Item Name: Crosstube Assembly, Mid Aft

DART AEROSPACE LTD	Work Order:	136988
Description: Crosstube Assembly, Mid Aft	Part Number:	D206-667-247
Inspection Dwg: D206-667-247 Rev: A		Page 1 of 2

DRAWING NO. D206-667-247
REV. A
SHEET 1 OF 4
TITLE CROSSTUBE ASS'Y (206L MID AFT)
SCALE NTS

DRAWING NO. D206-667-247	TITLE CROSSTUBE ASS'Y (206L MID AFT)	REV. A	DART AEROSPACE LTD ENGINEERING ORDER		D.E.O. NO. D206-667-247-A-1	SHEET NO. SHEET 1 OF 1	SCALE NTS
DRAWN <i>qp</i>	CHECKED <i>ASS</i>	MFG. APPR. <i>KB</i>	APPROVED <i>JMP</i>	DE APPR. <i>#</i>			
DATE 11.07.15	DATE 11.07.20	DATE 11.07.21	DATE 11/07/21	DATE 11.07.21

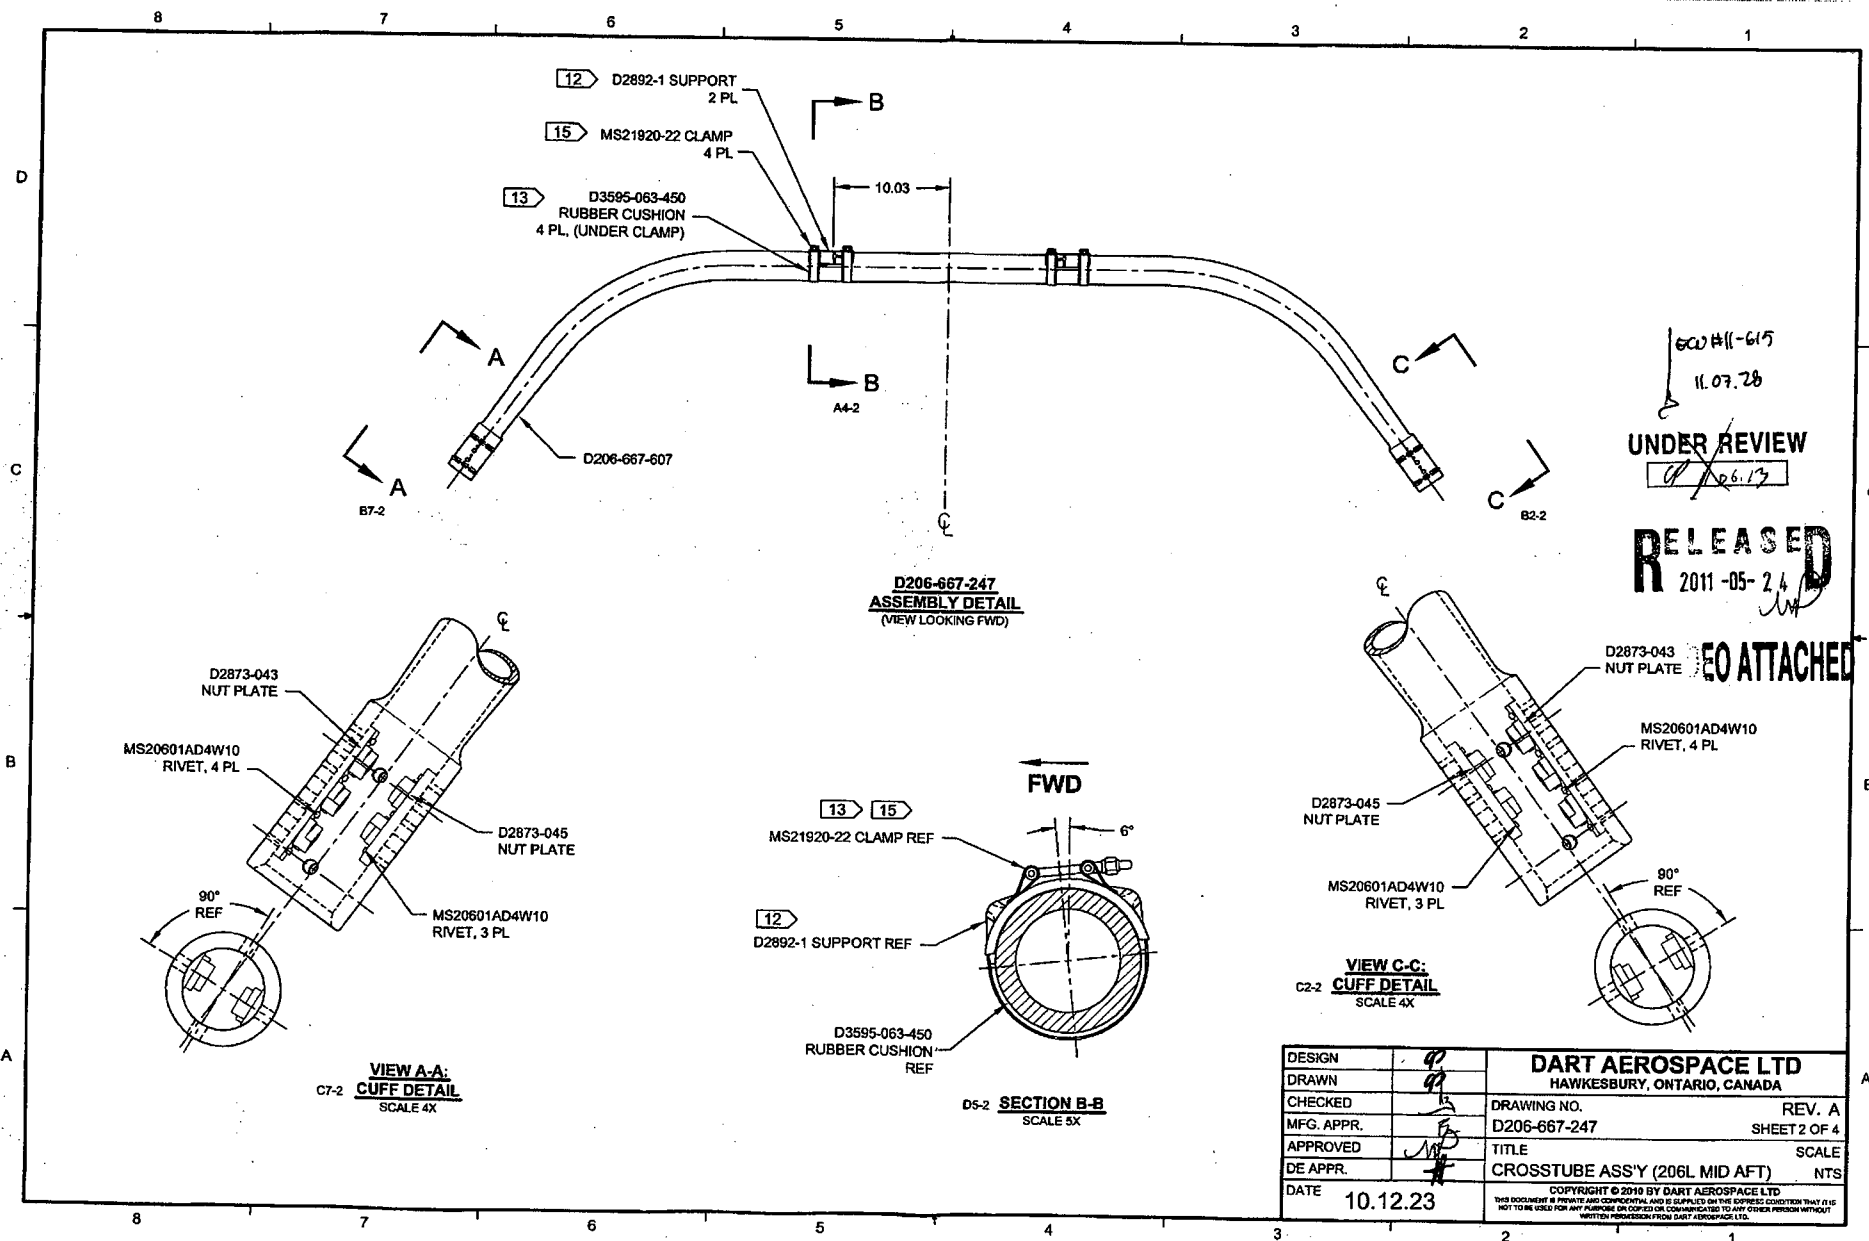
PURPOSE:

REPLACE MAGNOBOND WITH PROSEAL.

NOTE 12 & 15, SHEET 1 IS AMENDED AS FOLLOWS:

- 12) INSTALL D2892-1 SUPPORT USING 0.03" TO 0.06" THICK LAYER OF MAGNOBOND 6398 PER QSI 015. LET CURE FOR 12 HOURS AFTER INSTALLATION AND PRIOR TO PACKAGING.
- 15) TORQUE CLAMPS 80 TO 100 IN-LB. ENSURE AT LEAST 1.5 THREADS SHOWING IN SAFETY AND THAT NUT HAS NOT BOTTOMED-OUT AFTER TORQUING.

Item	Qty -247	Part Number	Description
9	A/R	PROSEAL 890 B-2	SEALANT, AMS-S-8802 CLASS B-2

- 12) TO INSTALL D2892-1 SUPPORT: ABRABE MATING SURFACE OF SUPPORT AND CROSSTUBE WITH 180-GRIT SANDPAPER AND REMOVE RESIDUE WITH MEK (OR EQUIVALENT). APPLY A 0.04" TO 0.07" THICK LAYER OF PROSEAL 890 CLASS B-2 (OR AMS-S-8802 CLASS B-2) SEALANT TO MATING SURFACE OF SUPPORT.
- 15) TORQUE CLAMPS 80 TO 100 IN-LB. ENSURE AT LEAST 1.5 THREADS SHOWING IN SAFETY AND THAT NUT HAS NOT BOTTOMED-OUT AFTER TORQUING. **PRIOR TO PACKAGING, RE-CHECK TORQUE ON CLAMPS AFTER PROSEAL 890 SEALANT HAS CURED FOR 72 HOURS.**
